MILITARY SPECIFICATION

ROTARY SWITCH AND HARNESS

This amendment forms a part of Military Specification MIL-R-82642(OS) of 25 July 1975.

Figure 2 Switch positions and tolerances.

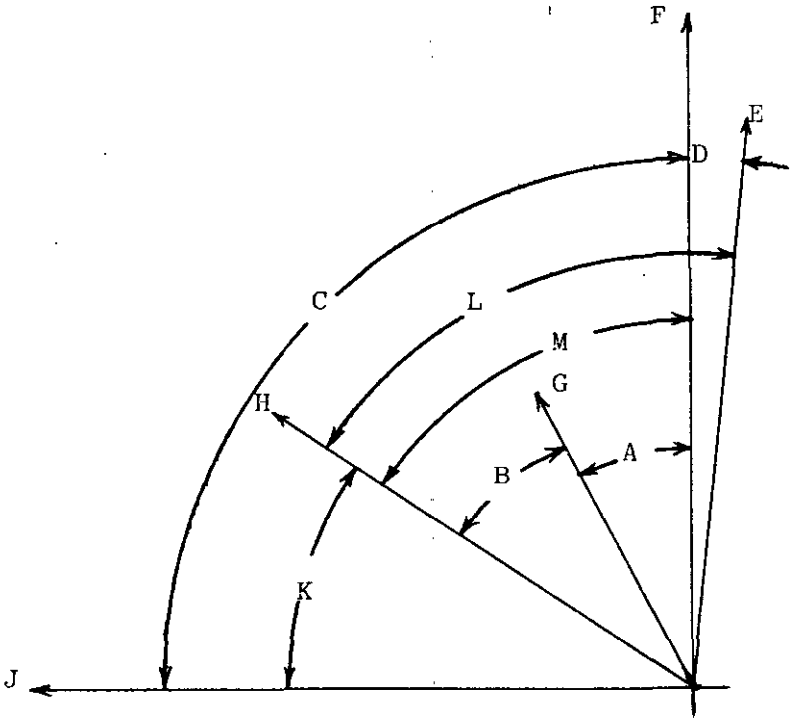
Figure 2. Delete and substitute:

3.9.1 Resistance (see Figure 2).

3.9.1.1 Open position. Angle (A + D) is the minimum angle of rotation from the open position stop to position One. Within this angle, there shall be continuity between the connector output contacts A and B and the ground wire terminal, along with a maximum resistance of 0.07 ohm. Simultaneously, there shall be an open circuit between the harness input terminals "A", "B", "C" and "D" and the connector output contacts.

3.9.1.2 Closed position stop. Angle K is the minimum angle of rotation from position two to the closed position stop. Within this angle there shall be continuity between the harness input terminals "A" and "C", "B" and "D" and the connector output contacts "A" and "B", respectively, along with a maximum resistance of 0.25 ohm. Simultaneously there shall be an open circuit between the connector output contacts and the ground wire terminal.

3.9.1.3 Switching function. Angle B is the zone of transition from the open to closed positions specified in 3.9.1.1 and 3.9.1.2 respectively. The switching function between the open and closed positions shall take place within this angle.

A	37°- 46°
B	5°- 20°
C	85°- 90°
D	5°- 10°
E	Open Position Stop
F	Zero Position
G	Position One
H	Position Two
J	Closed Position Stop
K	33°- 39°
L	56°- 67°
M	51°- 57°

Zero position is established when the flat of rotor is perpendicular to the "A" - plane shown on Drawing 2806551.
